LAWRENCE BERKELEY NATIONAL LABORATORIES FACILITIES DIVISION						
Scale: 1/8" = 1'-0"	Sheet no: S2.0	Project No: 6947816	Project ID: FNO100	Original sheet - A01	Drawn by NAL Date 11/14/2011	Checked by JRW Date 11/14/2011

REQUEST FOR INFORMATION

INFORMATION REQUESTED BY: Keith Mohler RFI #: 17

PROJECT: User Test Bed DATE: 12/12/12

2 ROTATING TEST BED FRAMING PLAN

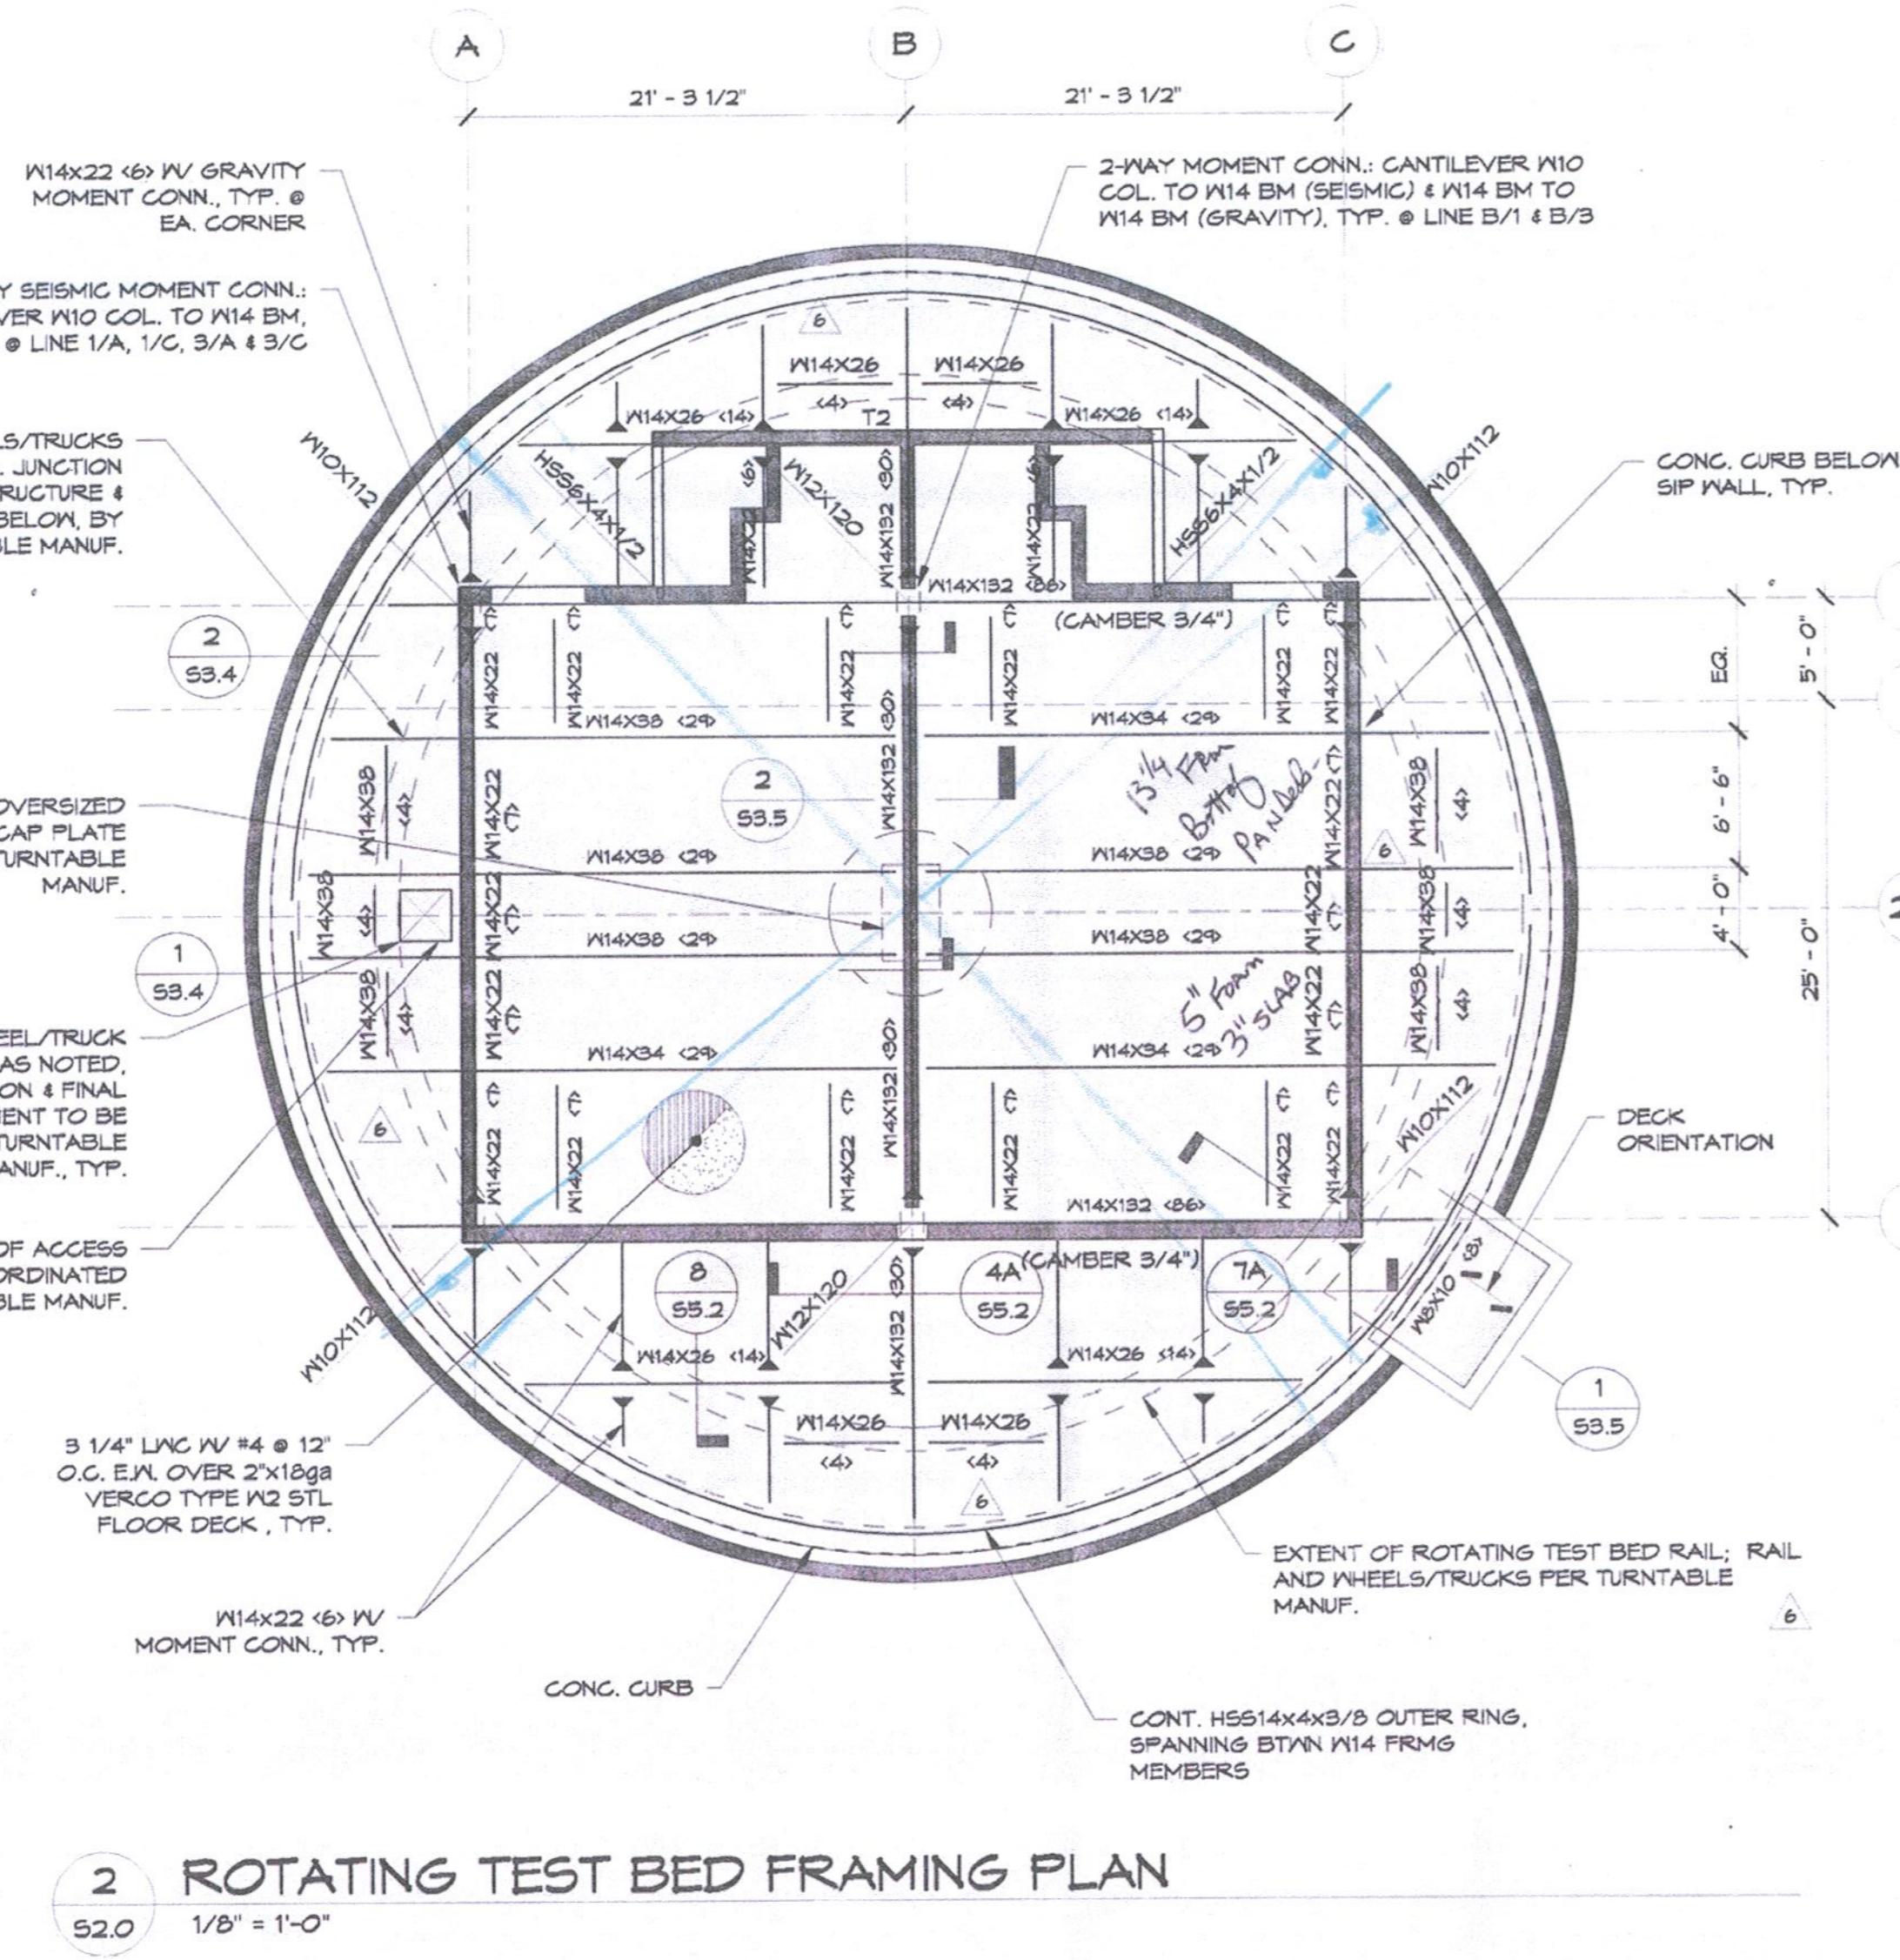
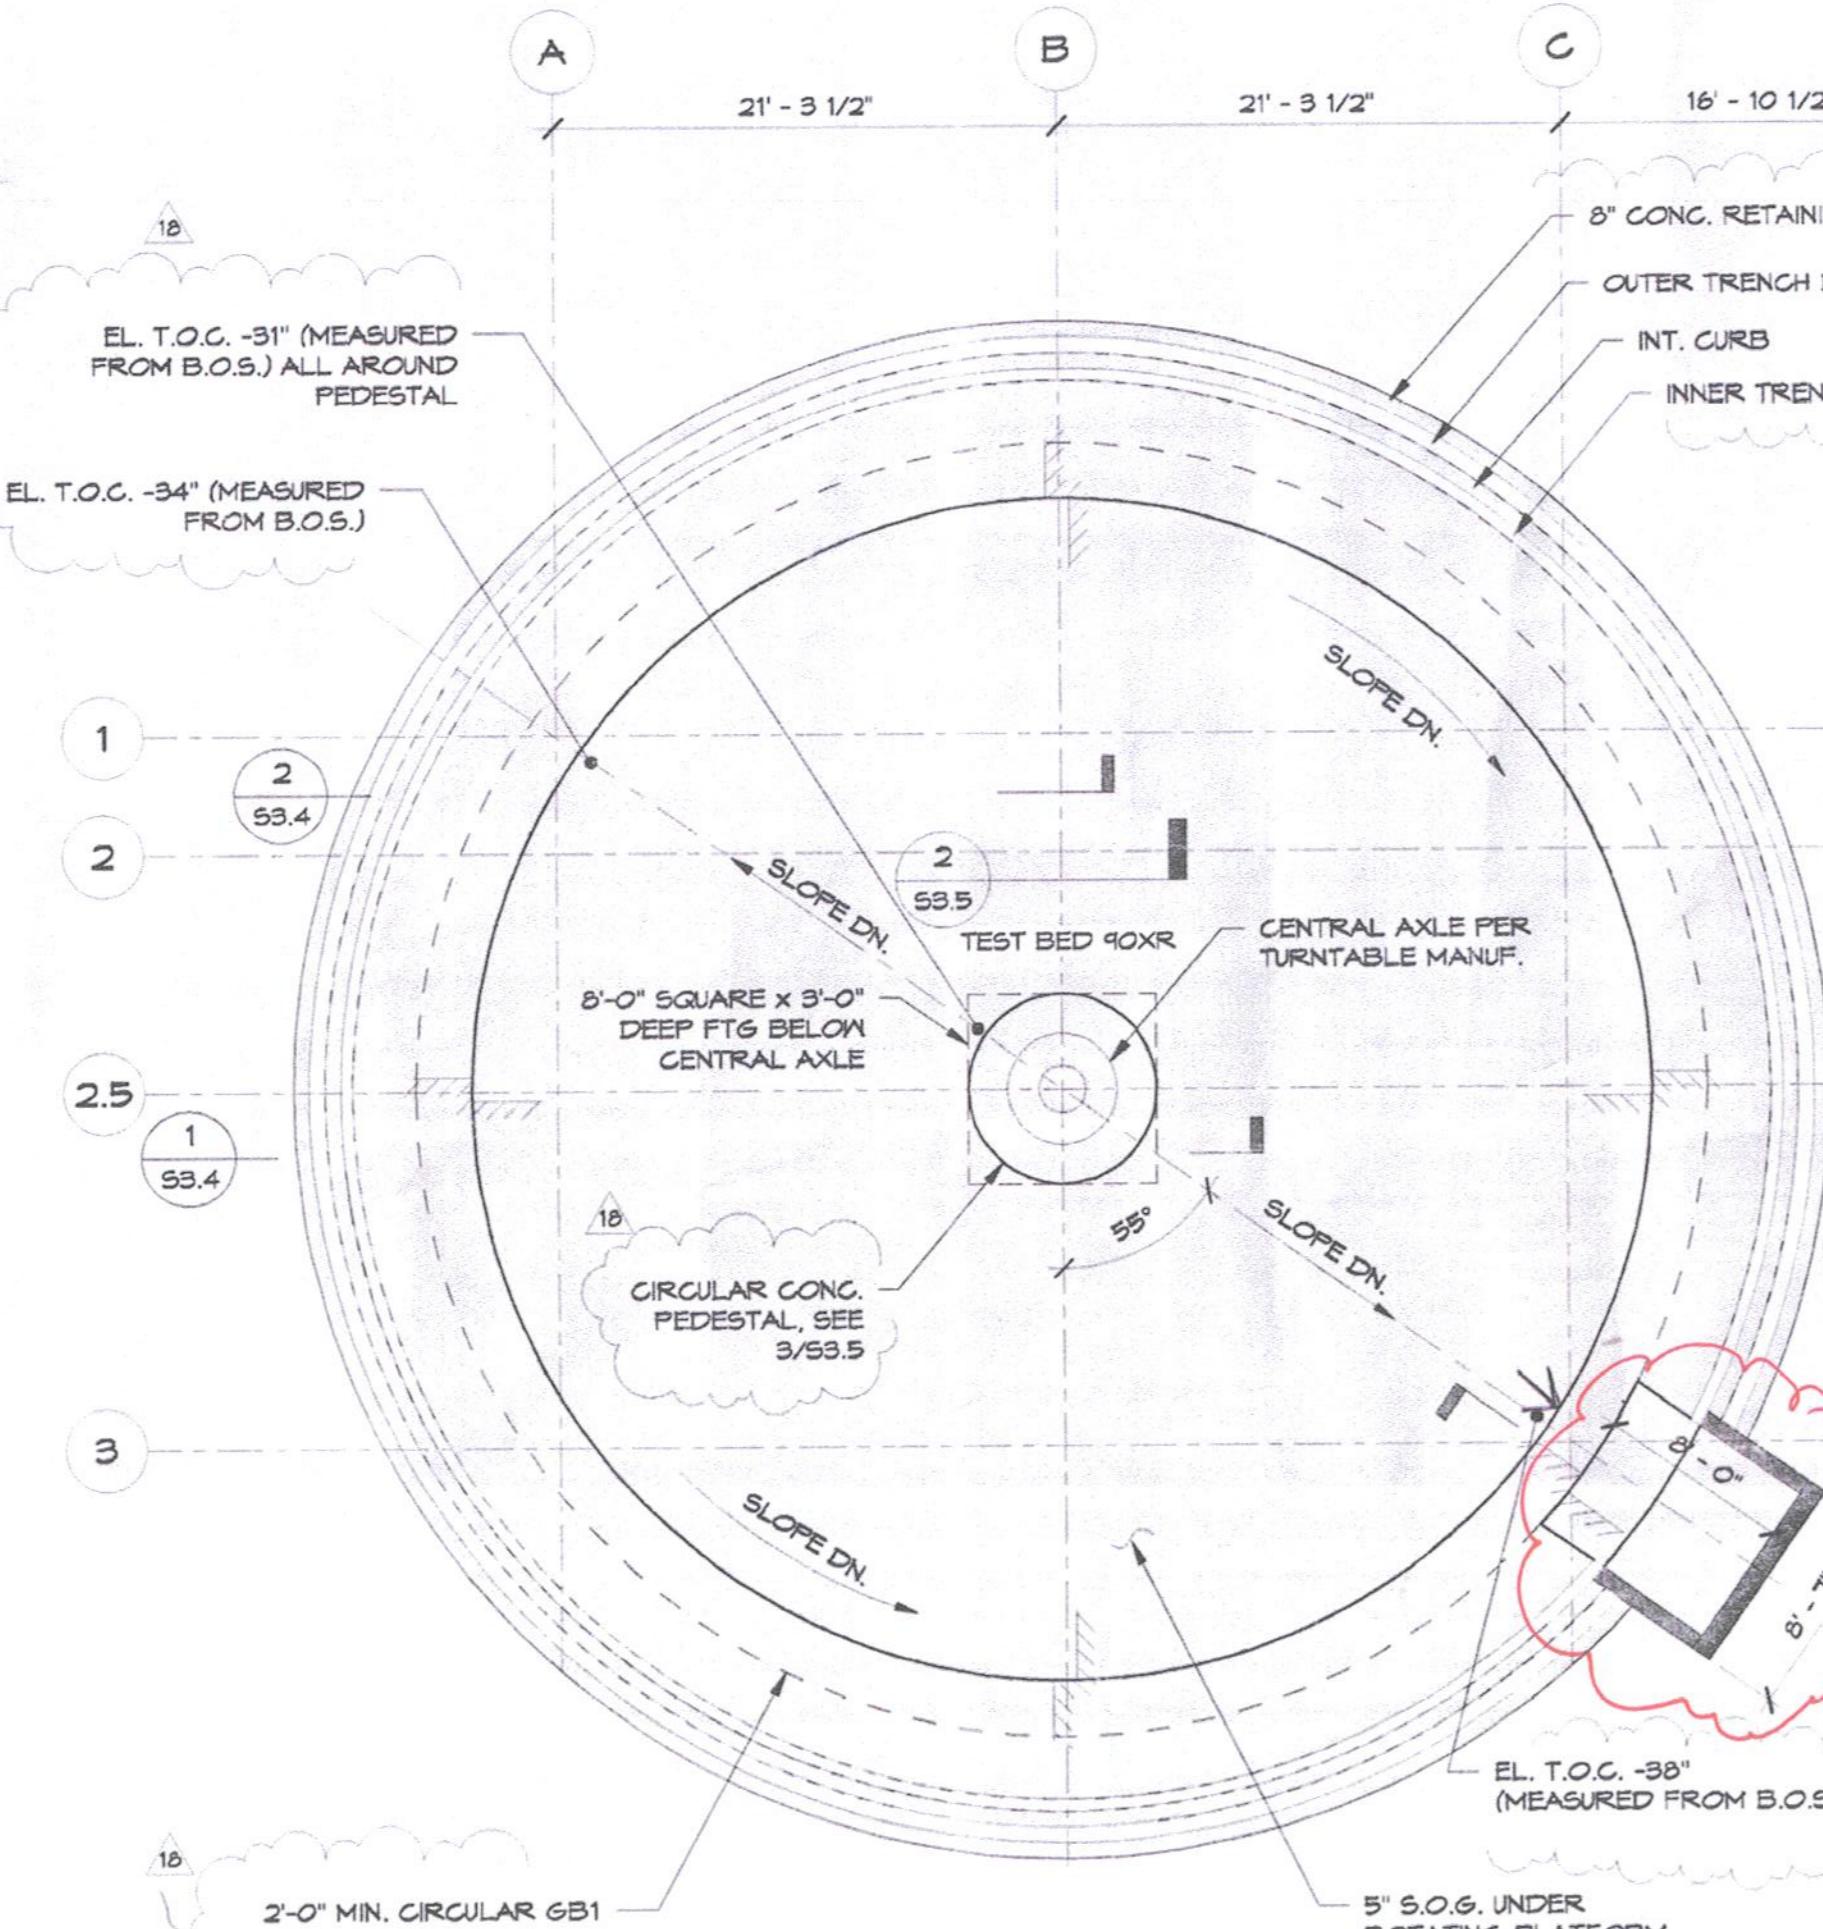
RFI 160
2-27-13

Response:- Confirmed- there should be a curb at line F between lines 1 and 2. Similarly also at line H between lines 1 and 2
 Exterior curb detail should be similar to 1/S3.2 and 3/S3.1 (except that its for a double SIP assembly). Note one detail number listed in RFI above is incorrect.
 Yes- Detail 1/S3.3 reflects the curb condition at line F between 2 and 3.
 However refer to detail 2/S3.1 for additional information on interior wall construction.
 Shalaka Chande
 Stantec
 03.11.2013

1 FOUNDATION PLAN

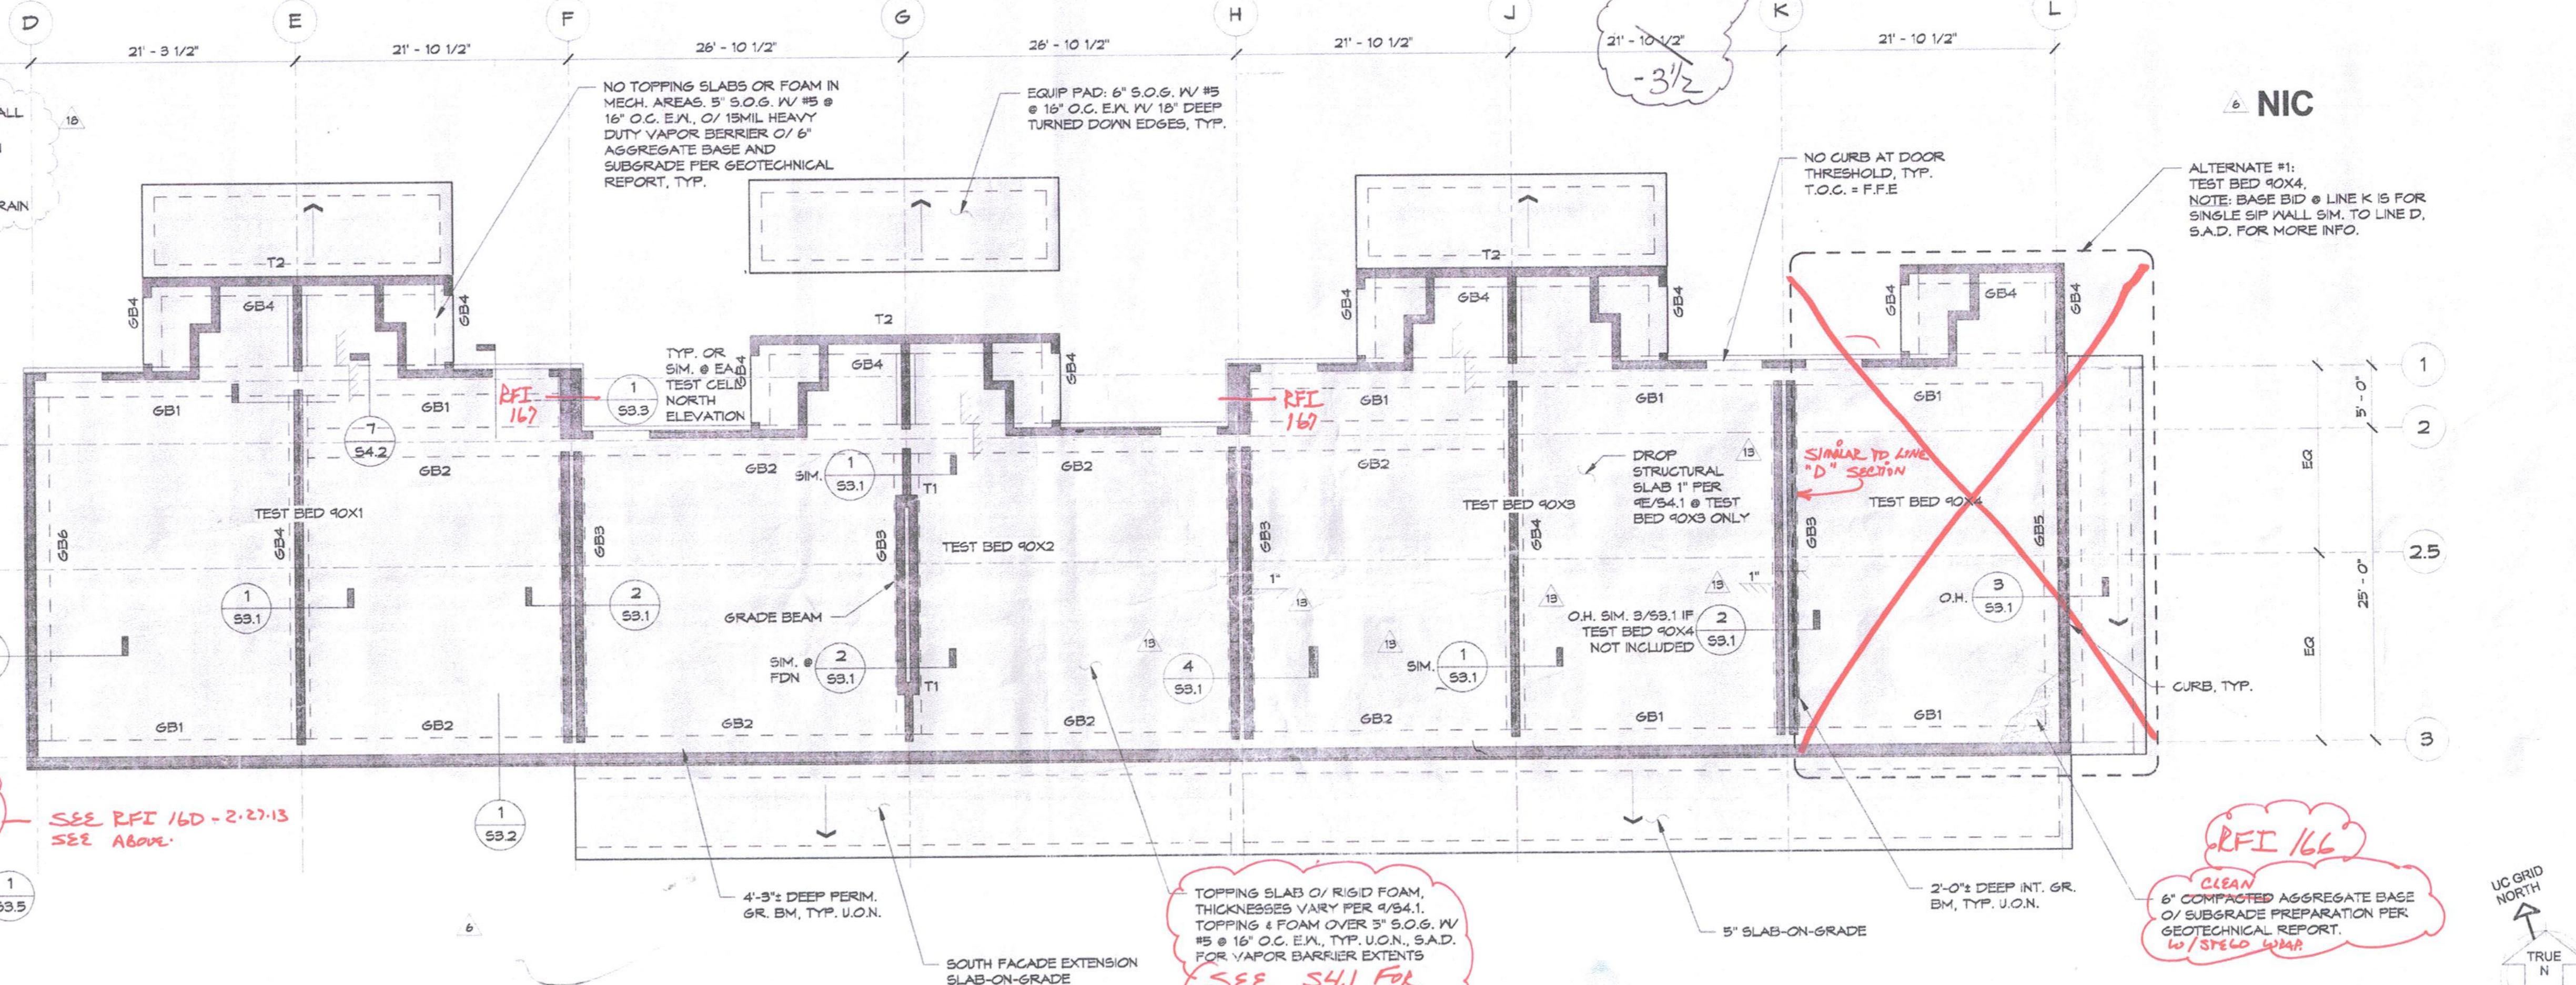
- Detail 1/S3.2 - Please provide the width of the south facade extension. **RFI BB**
- See attached S2.0 section. Should there be a Footing return wall near F line?
- Should the slab now stop at K line since K to L is out of the contract?
- Please provide the width of the curbs that sit on the beams - reference details 1-4/S3.1, details 1-2/S3.2 and details 1-2/S3.5

- See attached S2.0 section. Should there be a Footing return wall near F line?
- Based on typical 8-1/4" SIP panel width called out in the specs, the curb width at detail 1/A8.06 will be **16-1/2"** (typ at a double SIP assembly) and will be **8-1/4"** at detail 1/A8.07 (typ at a single SIP assembly).

- Please confirm extension slab width dimension with Arch.
- Confirm. There should be a return footing near Line F as shown in the attached portion of S2.0.
- Please confirm final extension slab extends with the building.
- Curb widths to match framing including sheathing, as shown in the details, U.O.N. Curb width at North and South Facades (1/S3.2) is 7'-1". See SSD-11 (S3.2) attached.

- Extension slab width dimension to be 7'-8" (from face of concrete curb).
- Confirmed. Slab from K to L is NIC. Exterior wall at column K should be similar to wall at column line D.

Width of curb (above grade) between the electrical/mechanical room wall and the test bed shall be per plan details 1/A/S3.3 and 1/A/S3.6 on ASI 16.1 (i.e. curb to align with F.O. SIP which is **8-1/4"** at sip panel and **6-1/2"** wide at metal stud wall as shown).

Below grade beam to be **1-2"** from grid to outside face of grade beam per revised section detail 1/S3.2 on ASI#16.2.

Please note: The actual concrete curb width should be determined in coordination with the framer- based on SIP panel dimensions provided, plus construction tolerance or other considerations by the Contractor. *Confirms by Keith of LOS GATOS 3-6-13*
